DOCKETED		
Docket Number:	08-AFC-07C	
Project Title:	GWF Tracy (Compliance)	
TN #:	210295	
Document Title:	Notice of Determination	
Description:	supersedes TN 210292	
Filer:	Joe Douglas	
Organization:	California Energy Commission	
Submitter Role:	Energy Commission	
Submission Date:	2/12/2016 2:03:06 PM	
Docketed Date:	2/12/2016

NOTICE OF DETERMINATION PETITION TO AMEND THE GWF TRACY COMBINED CYCLE POWER PLANT (08-AFC-7C)

ENVIRONMENTAL JUSTICE POPULATION FIGURE

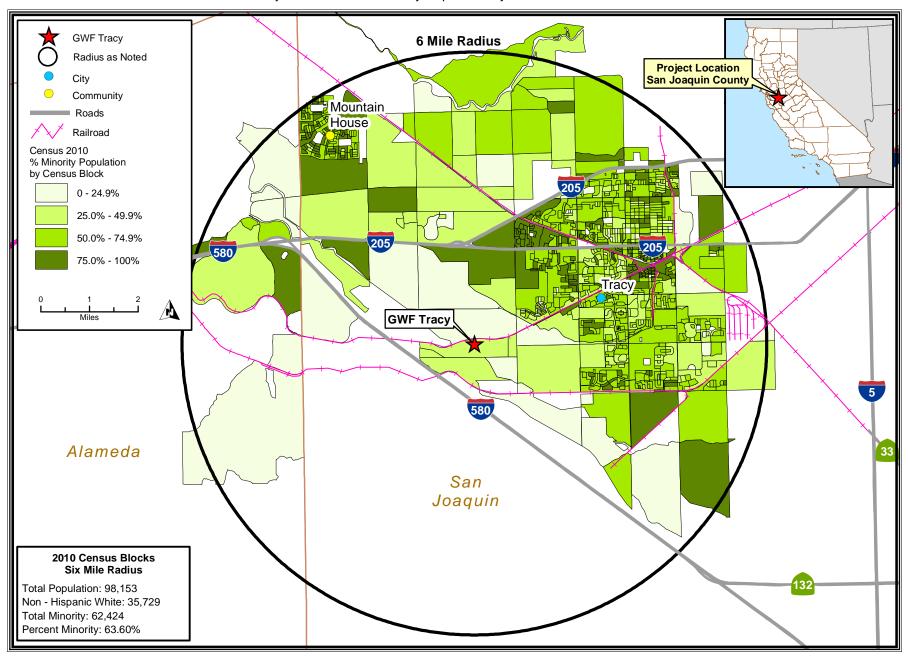
Also, the proposed changes would not cause any significant impacts to any population within the six-mile radius of GWF Tracy, including the environmental justice population identified in the **Environmental Justice Population Figure** (attached).
